<div>ABBOTT ADD</div>	<div>INDEX</div> <div>TECHNICAL SERVICE BULLETIN</div>
--	--

PRODUCT: LCx® Probe System (69)	DATE: 25-AUG-97
------------------------------------	--------------------

SUBJECT:
LCx® Analyzer Version 2 Software Upgrade
(System Software Module Version 2 and
Assay Software Module 2 Version 1.0)

TSB#: 69-005

Figure 1: Ground Cable Assembly

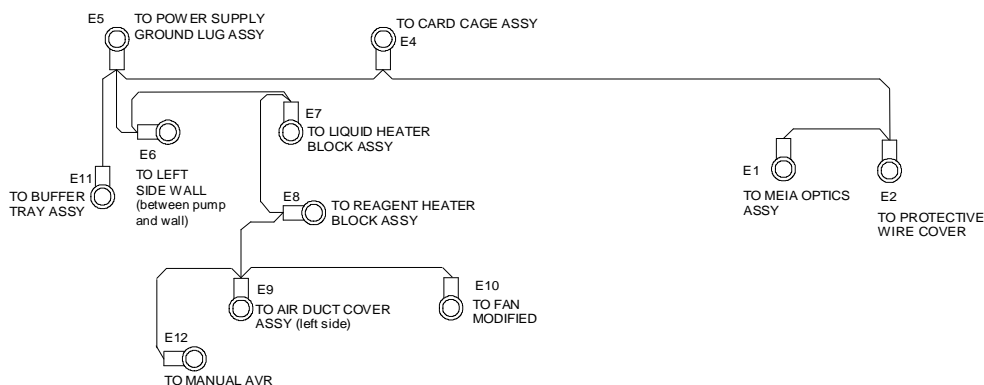
1. Install the Ground Cable Assembly. (Figure 1)
 - a. Install the ground terminal lug E5 to the Power Supply Ground Lug Assembly.
 - b. Route the Buffer Tray ground terminal lug E11 under the pump frame and attach to the Buffer Tray Assembly.
 - c. Attach the ground terminal lug E6 to the left side wall.
 - d. Route the Modified Fan ground terminal lug E10 under the Reagent Heater Block Assembly and attach to the Modified Fan.
 - e. Attach the Air Duct Cover Assembly ground terminal lug E9 to the left side of the Air Duct Cover Assembly.
 - f. Attach the Reagent Heater Block Assembly ground terminal lug E8 to the Reagent Heater Block Assembly.

- g. Attach the Liquid Heater Block Assembly ground terminal lug E7 to the Liquid Heater Block Assembly.
- h. Attach the Card Cage Assembly ground terminal lug E4 to the Card Cage Assembly.
- i. Route the Ground Cable Assembly through the cable clamps along the base of the sheet metal assembly.
- j. Loosen the screw securing the PMT HV Power Supply and route the Ground Cable Assembly behind the post and under the PMT HV Power Supply.
- k. Attach the MEIA Optics Assembly ground terminal lug E1 to the MEIA Optics Assembly.
NOTE: Attach the Protective Wire Cover ground terminal lug E2 to the Protective Wire Cover after cover is reinstalled.

Figure 2: LLS/Analog Cable Assembly

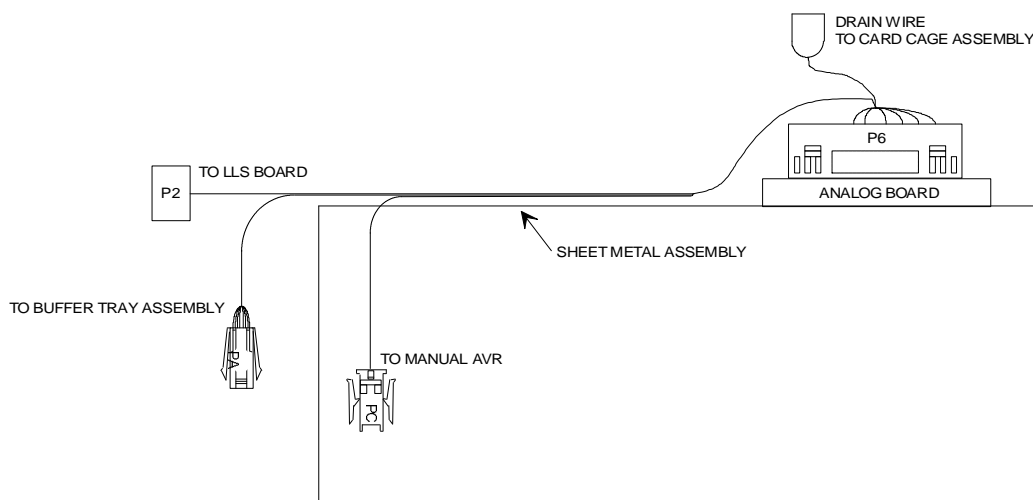
1. Connect the LLS/Analog Cable Assembly connector PA to the Buffer Tray Assembly connector JA. See (Figure 2)
2. Secure only the cable to the Buffer Tray Assembly to the boss, located behind the Pump Assembly and next to the left sheet metal wall, using clamp and screw removed earlier.
3. Connect the LLS/Analog Cable Assembly connector P2 to the LLS Board.
4. Route the manual AVR connector PC along the left side of the Reagent Receiver/Heater Block Assembly.
5. Route the cable along the base and secure with the two (2) cable clamps.
6. Connect the LLS/Analog Cable Assembly connector P6 to the Analog Board.
7. Connect the Drain Wire to the Card Cage.

Figure 3: Amplification Vial Retainer (AVR)

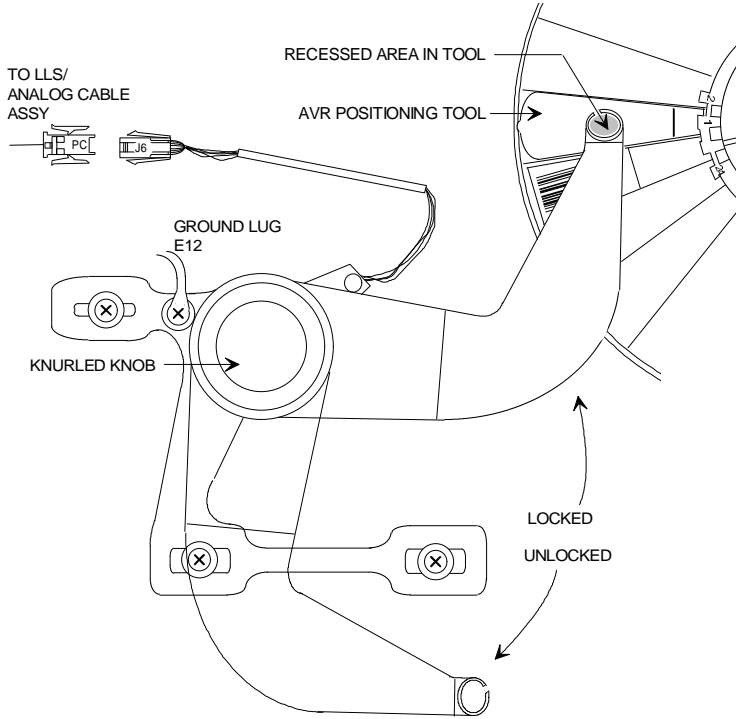
This TSB provides for the incorporation of the manual Amplification Vial Retainer (henceforth referred to as the AVR) into the LCx Analyzer. The manual AVR (Figure 3) is an elongated hook mounted onto the left side of the Air Duct Cover and placed in front of the Reagent Heater Block. The manual AVR remains stationary during all testing. The operator locks the AVR into position by turning the knurled knob counterclockwise until the AVR clicks into position. The AVR is unlocked by turning the knurled knob clockwise. Because the AVR does not travel with the Boom Assembly and remains stationed over the amplification vial, there is no opportunity for bridging of fluid between the probe and AVR surface when the probe is situated over the diluent well of the reaction cell. The manual AVR must be locked during all assay testing and unlocked during all system checks and calibrations. The system software checks the lock sensor before and during the assay (ERROR CODE 93: "CAROUSEL LOCK ARM NOT LOCKED" will be displayed if the AVR is not locked). The AVR is electrically connected to the Analog Board via the LLS/Analog Cable Assembly. The functionality of the AVR home sensor may be verified at the level of the DISPENSE HAND CONTROLS.

- d. Visually align the oval shaped opening at the end of the arm with the corresponding recessed oval area of the target on the alignment tool. (Figure 3)

- b. Lock the AVR arm by turning the knob counterclockwise.
 - c. From the MAIN MENU:
Press MONITOR.
HND-CTRL
OTHER
OTHER
LS
OTHER
OTHER
CR_POS1
 - d. Visually align the oval shaped opening at the end of the arm with the corresponding recessed oval area of the target on the alignment tool. (Figure 3)

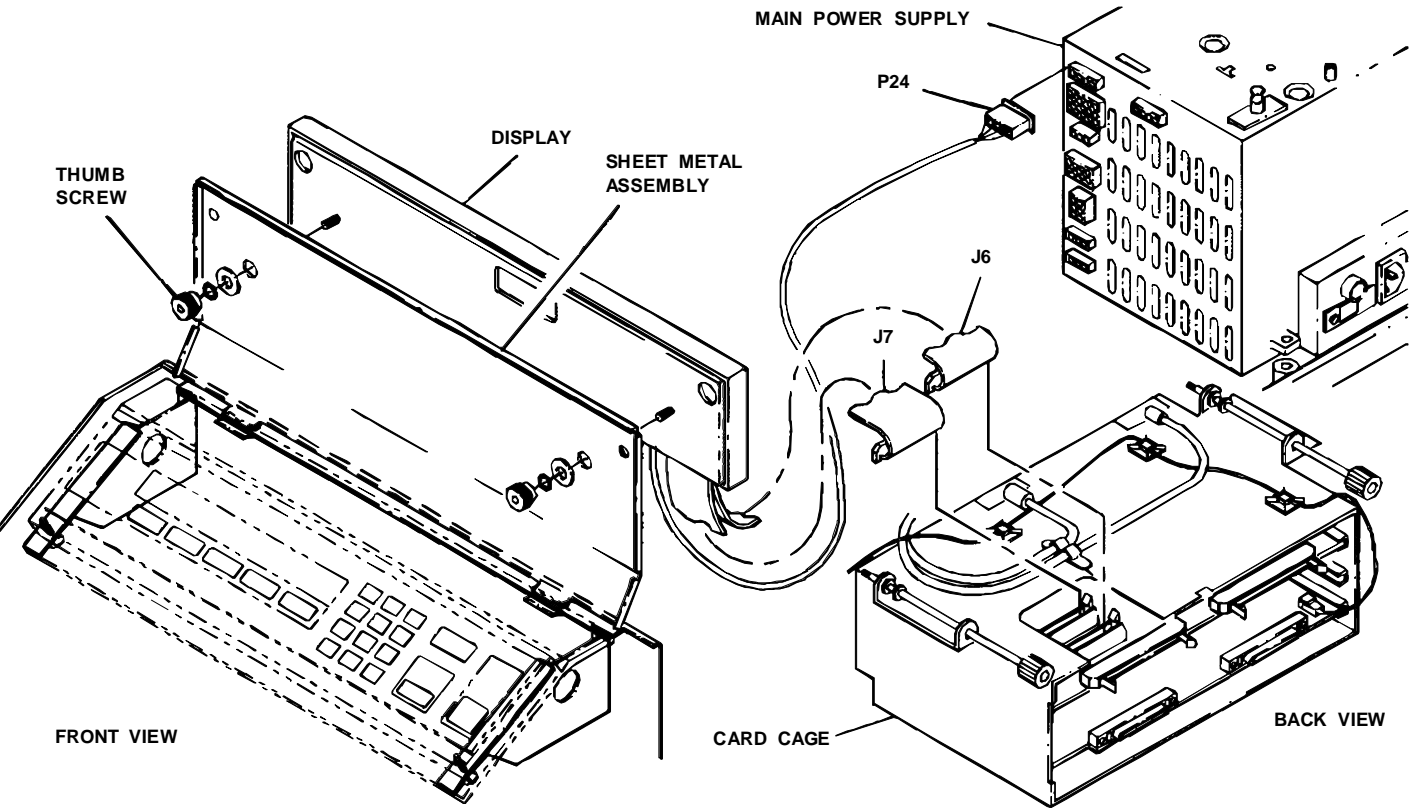
8. Disconnect the Display and Touchpad Cables (J6 and J7) from the Digital I/O Board (See Figure).
9. Disconnect the Touchpad Assembly Power Cable (P24) at the Main Power Supply (See Figure).

10. Remove Right VDE Cover (3 mounting screws).
11. Remove two (2) Thumbscrews and hardware attaching Touchpad Assembly to sheet metal assembly (See Figure) and remove the Touchpad Assembly. (See also LCx Analyzer Service Manual RR 8.1 for step 8, 9, 10 and 11.)

12. Install the new Touchpad Assembly. Attach Touchpad Assembly to sheet metal assembly. Secure Assembly with two (2) Thumbscrews and hardware.
13. Route the Touchpad Assembly power cable (P24) to the Main Power Supply and connect it (at J24) (See Figure).
